SOUTHERN GROVE 4

Master Planned Unit Development MPUD
Amendment #2

City Project Number: ~~P20-111~~ P22-227
Ordinance 22 -
PSLUSD Project No: 11-900-00

LIST OF AMENDMENTS (Amendment #2)

Conceptual Land Use Plan

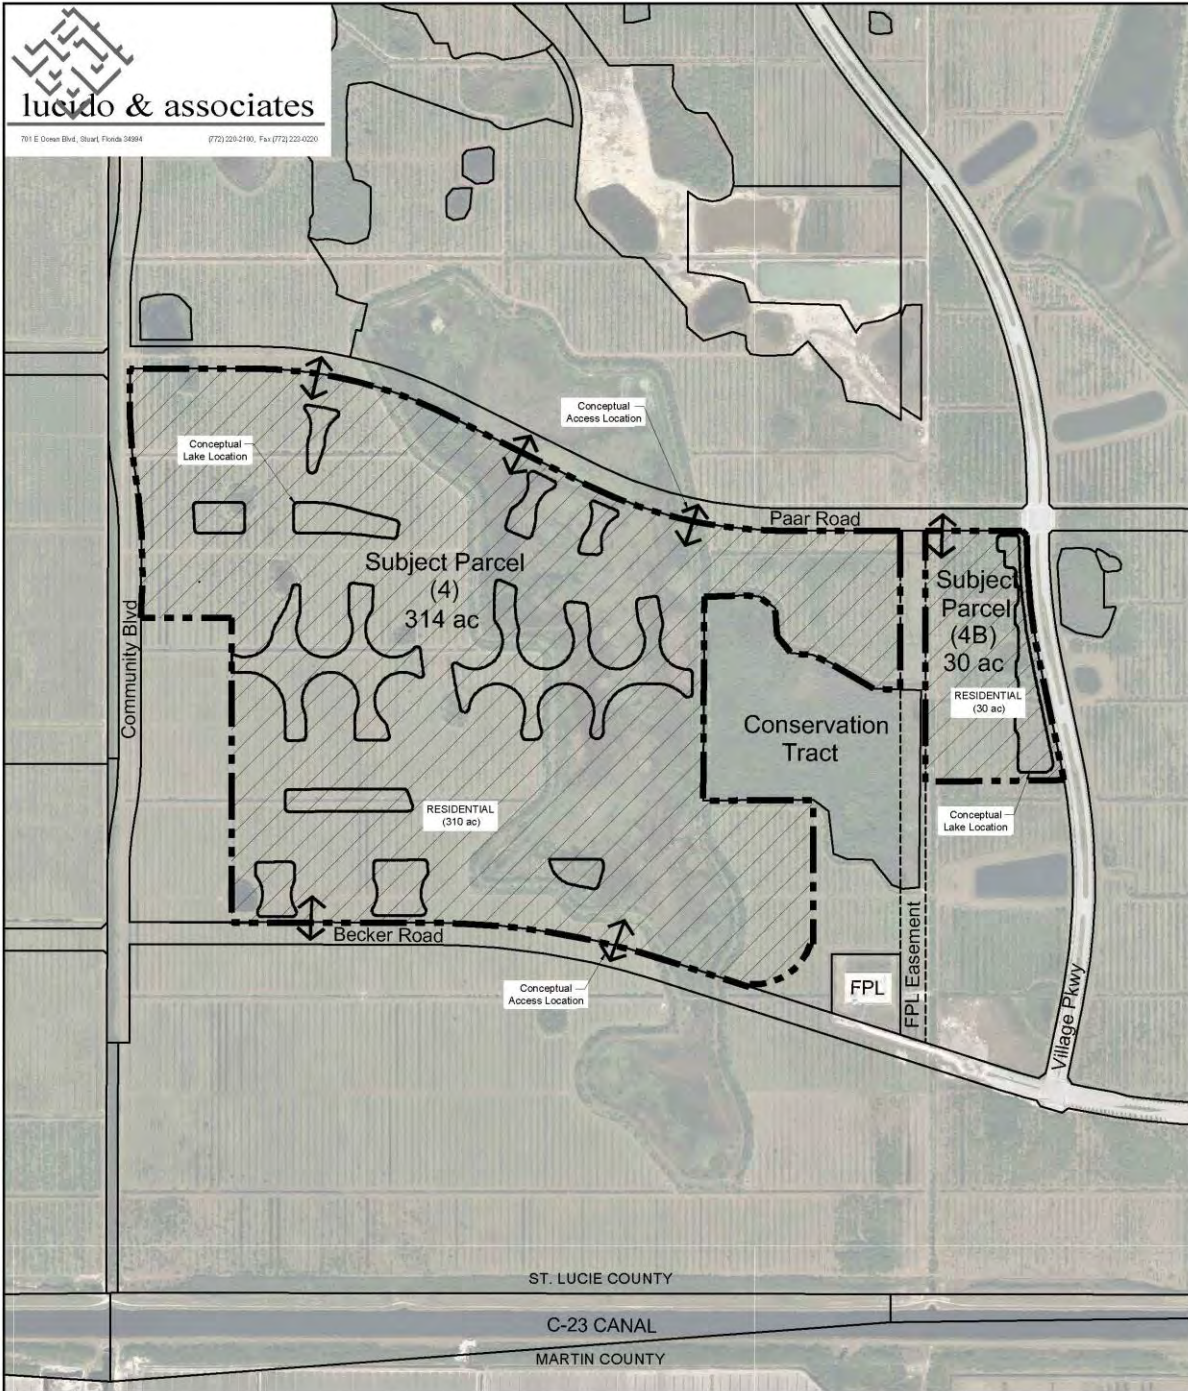
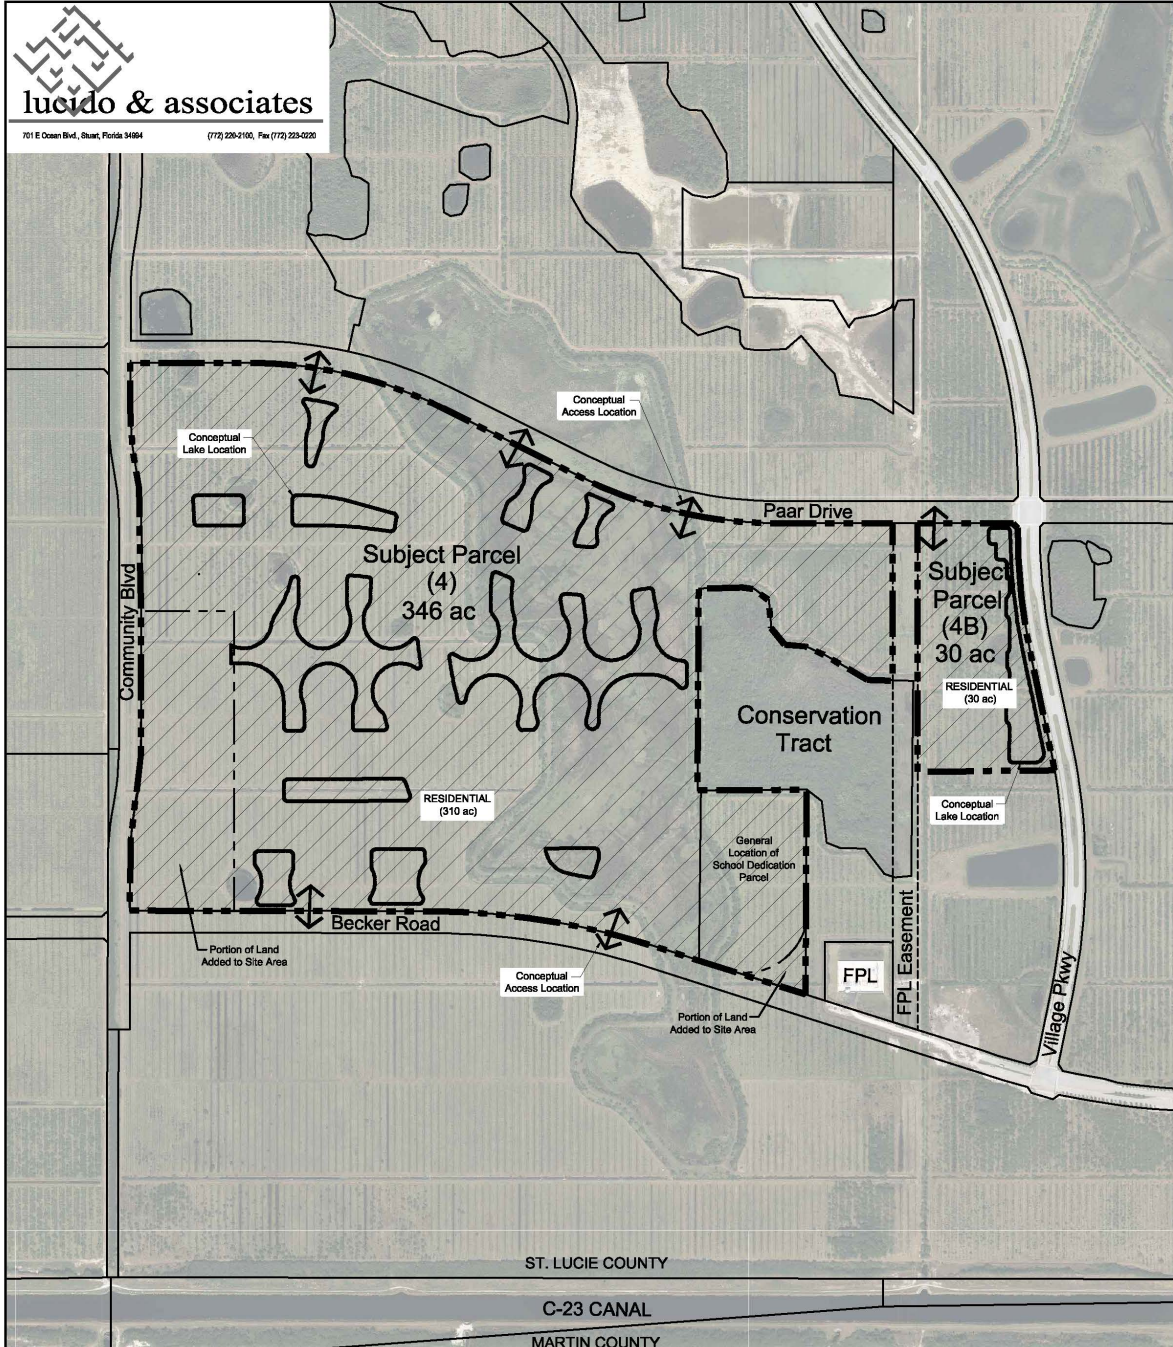
- Adjust MPUD parcel boundaries to add approximately 31.78 ac of land to the development area and adjust all maps and exhibits accordingly
- Include documentation to reflect ownership entities of Mattamy Palm Beach, LLC and CCC-PSL, LLC
- Provide sketch and legal descriptions for additional land area
- Refine terminology to include ‘multi-family horizontal’ and ‘multi-family vertically attached’ development programs
- Refinement of miscellaneous development criteria language as directed by the City
- Revise/add language regarding perimeter landscape buffer strips and wall requirements
- Revise conceptual land use plan to eliminate access arrows along Community Blvd

Note: Final arrangement of site-specific elements such as vehicular access locations, lakes, etc. shall be determined at time of site plan development
